PENNSYLVANIA ELECTRIC COMPANY
THREE MILE ISLAND NUCLEAR STATION UNIT 1

Operating License No. DPR-50
Docket No. 50-289
Technical Specification Change Request No. 45

Technical Specification Change Request No. 45

Figure 3.5-2B

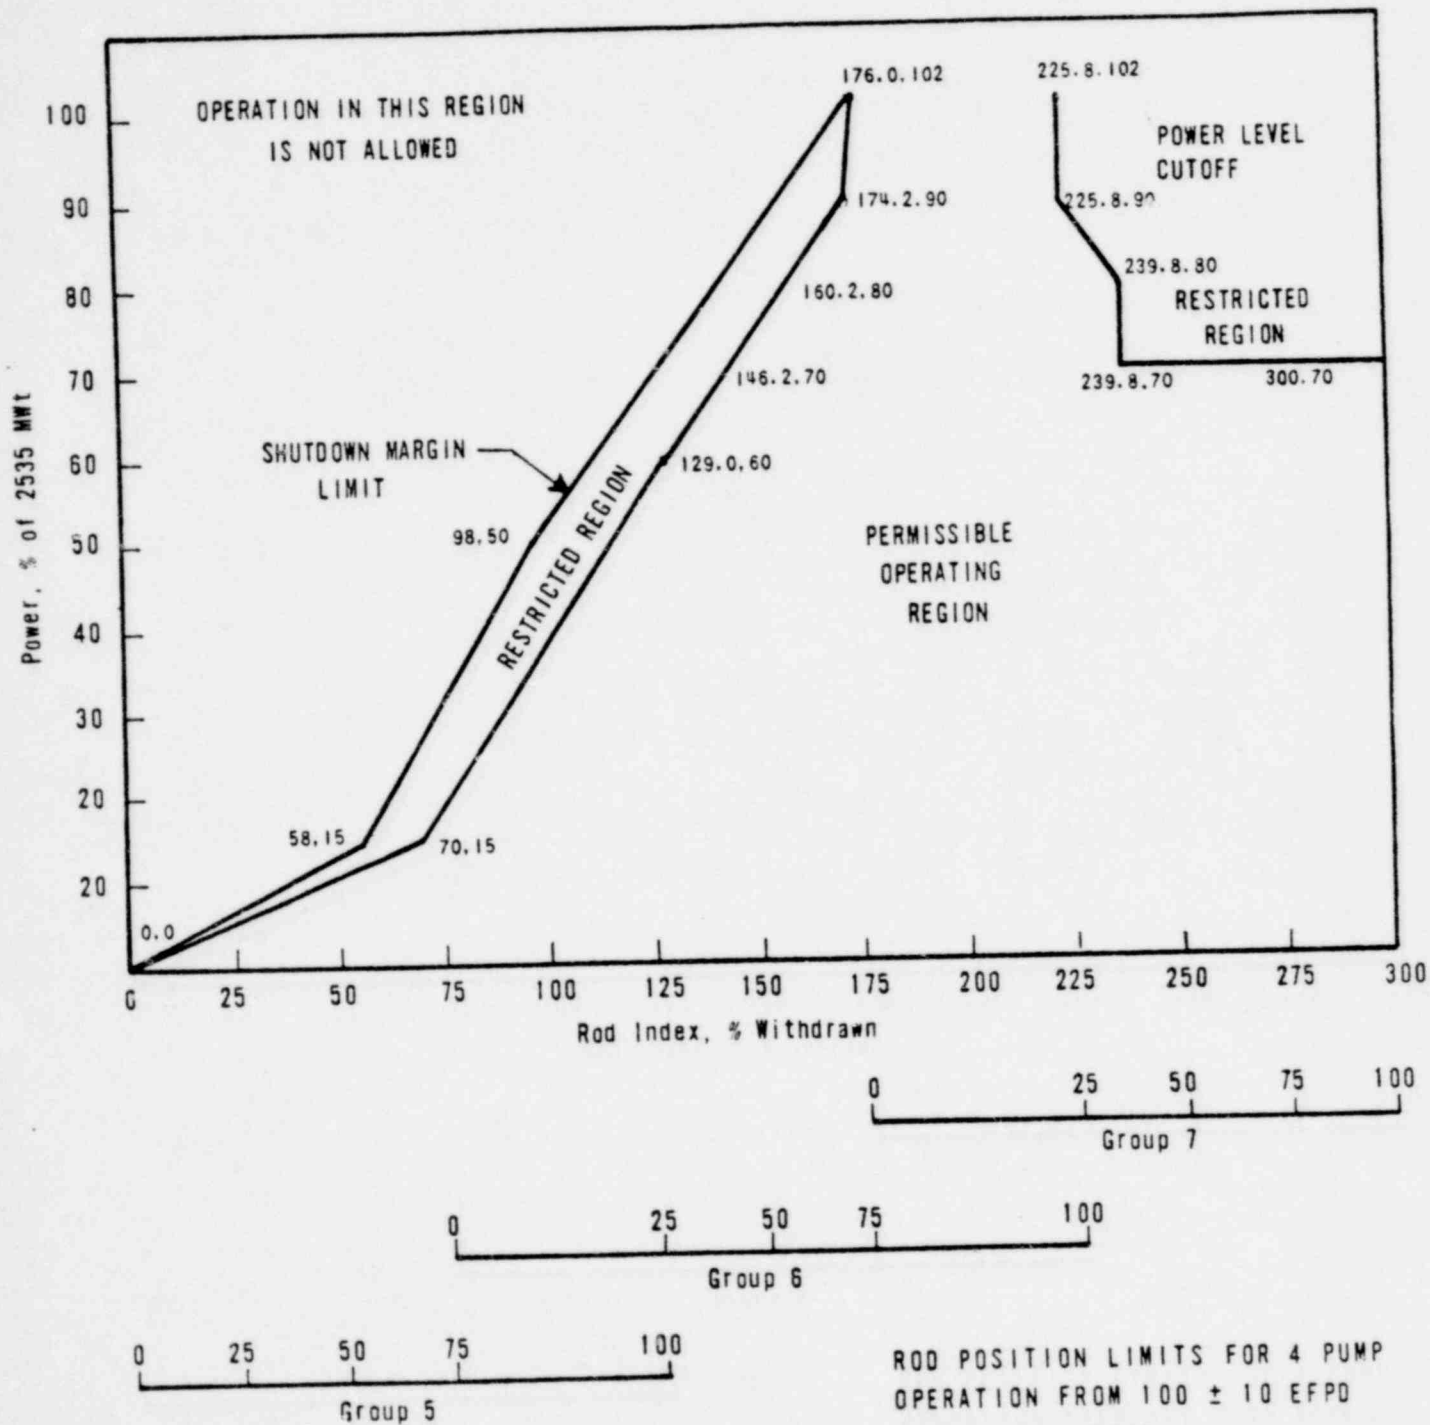
The Licensee requests that the attached changed pages replace pages v, vi, vii, 1-5, 2-3, 2-5, 2-6, 2-7, 3-1, 3-2, 3-34, 3-34a, 3-35, 3-35a, 3-36, 4-59 figures 2.1-1, 2.1-2, 2.1-3, 2.3-1, 2.3-2, 3.5-2A through 3.5-2J and table 2.3-1 of the existing technical specifications.

- d. Except for physics tests if quadrant tilt exceeds the tilt limit power shall be reduced immediately to below the power level cutoff (see Figures 3.5-2A, 3.5-2B and 3.5-2C). Moreover, the power level cutoff value shall be reduced 2 percent for each 1 percent tilt in excess of the tilt limit. For less than four pump operation, thermal power shall be reduced 2 percent of the thermal power allowable for the reactor coolant pump combination for each 1 percent tilt in excess of the tilt limit.

2. The control rod group withdrawal limits (Figures 3.5-2A, 3.5-2B, 3.5-2C, 3.5-2D, 3.5-2E, 3.5-2F, 3.5-2K, 3.5-2L, and 3.5-2M) shall be reduced 2 percent in power for each 1 percent tilt in excess of the tilt limit.

Figure 3.5-2G

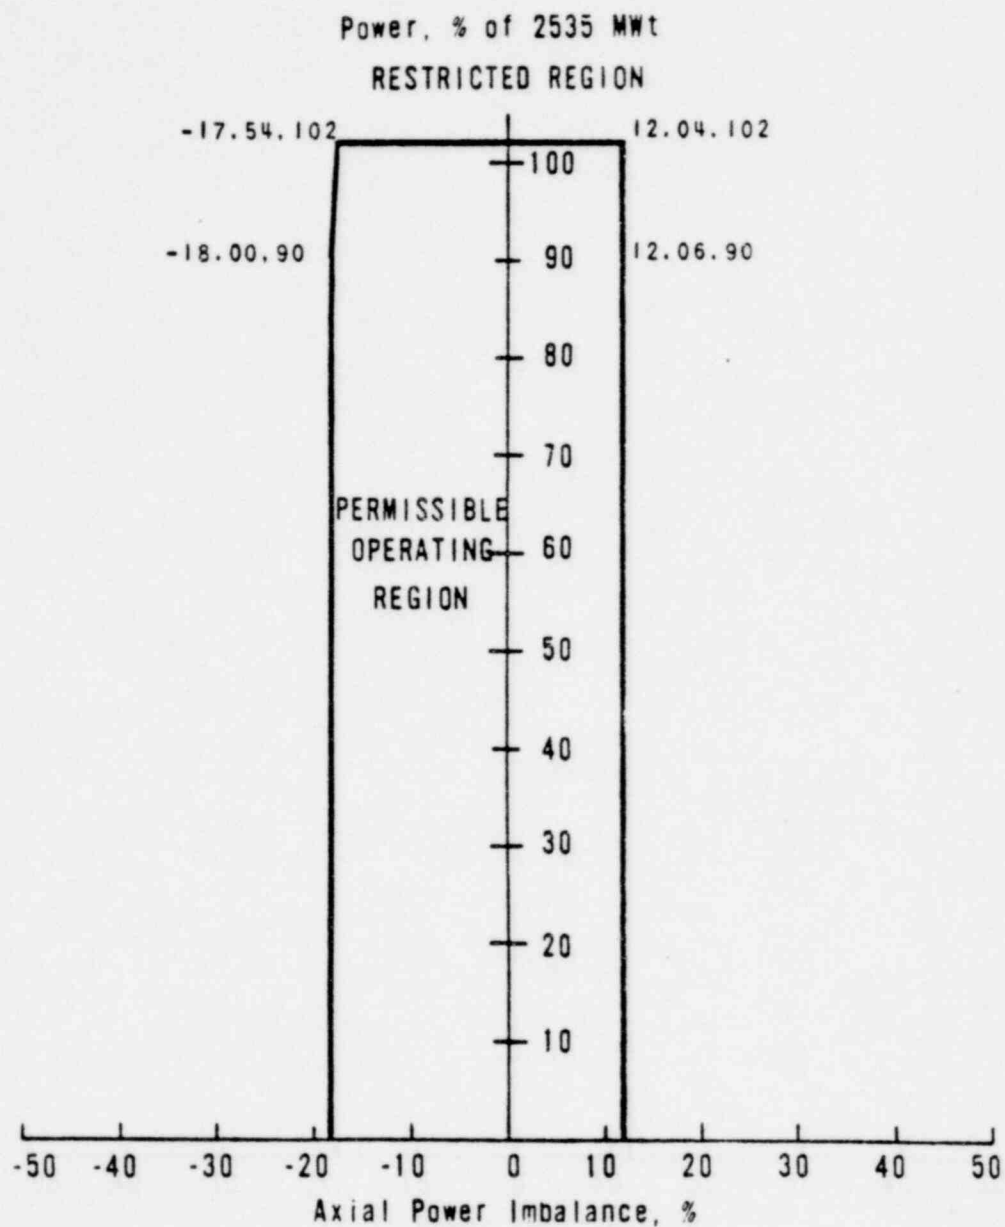
3. The operational imbalance limits (Figure 3.5-2G, 3.5-2H and 3.5-2I) shall be reduced 2 percent in power for each 1 percent tilt in excess of the tilt limit.

The power-imbalance envelope defined in Figures 3.5-2G, 3.5-2H, and 3.5-2I is based on LOCA analyses which have defined the maximum linear heat rate (see Figure 3.5-2J) such that the maximum clad temperature will not exceed the Final Acceptance Criteria (2200F). Operation outside of the power imbalance envelope alone does not constitute a situation that would cause the Final Acceptance Criteria to be exceeded should a LOCA occur. The power imbalance envelope represents the boundary of operation limited by the Final Acceptance Criteria only if the control rods are at the withdrawal/insertion limits as defined by

Figure 3.5-21

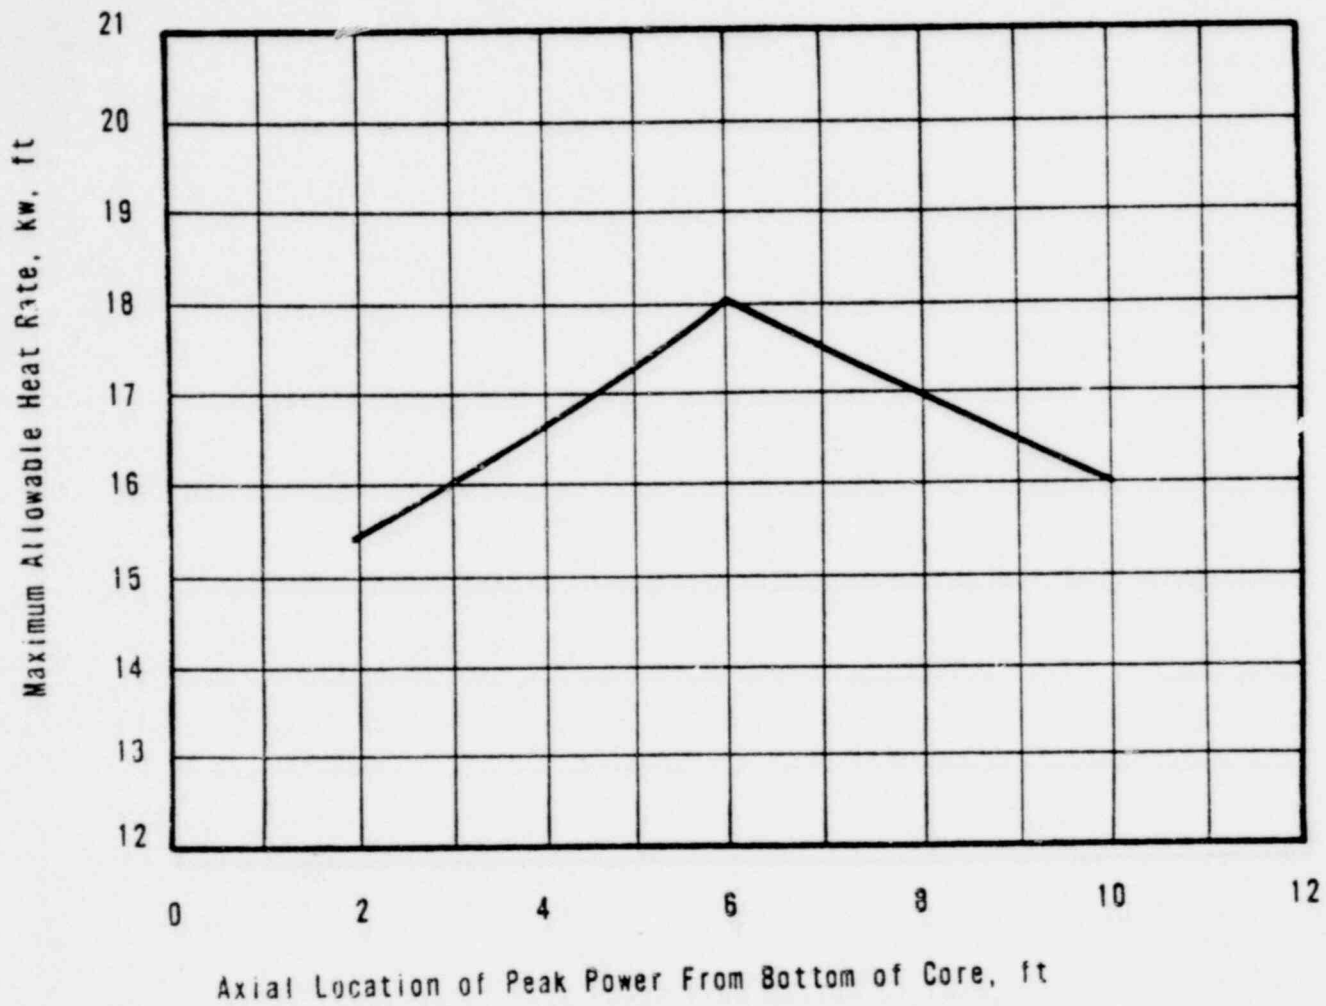
3.5.2.7 A power map shall be taken at periodic intervals of 30 full power days using the incore instrumentation detection system, to verify that the power distribution is within the limits shown in Figure 3.5-2 J.

Figure 3.5-2K

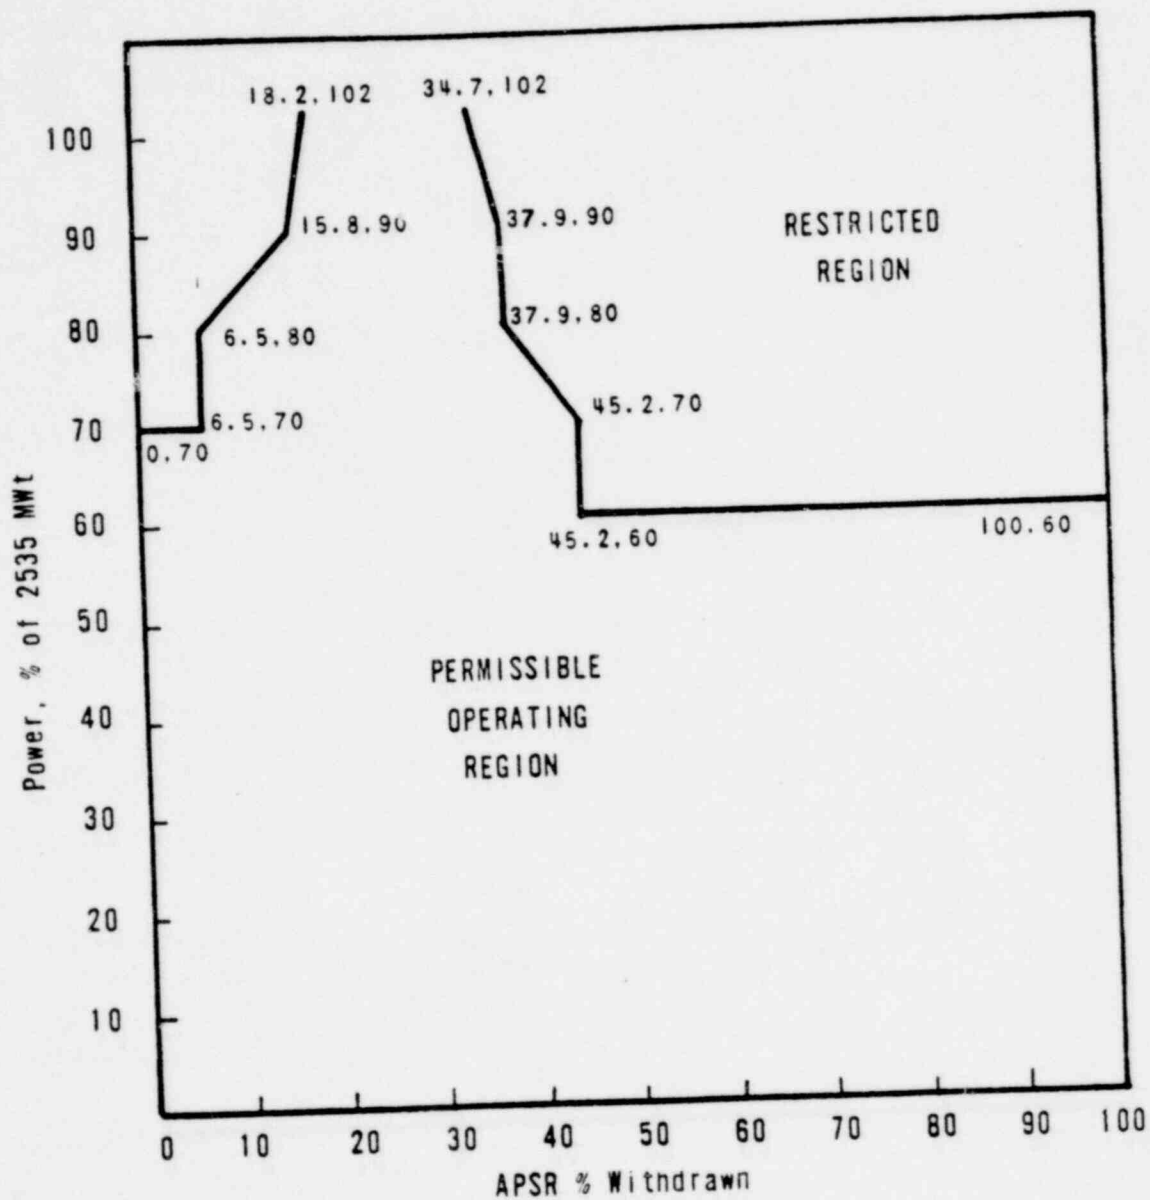
Limits for the APSR's have been established which provide additional control of power peaking through an improved definition of core power distribution. This change provides additional operating flexibility while at the same time not reducing the degree of conservatism relative to the limits that would be appropriate if no APSR limits were specified.
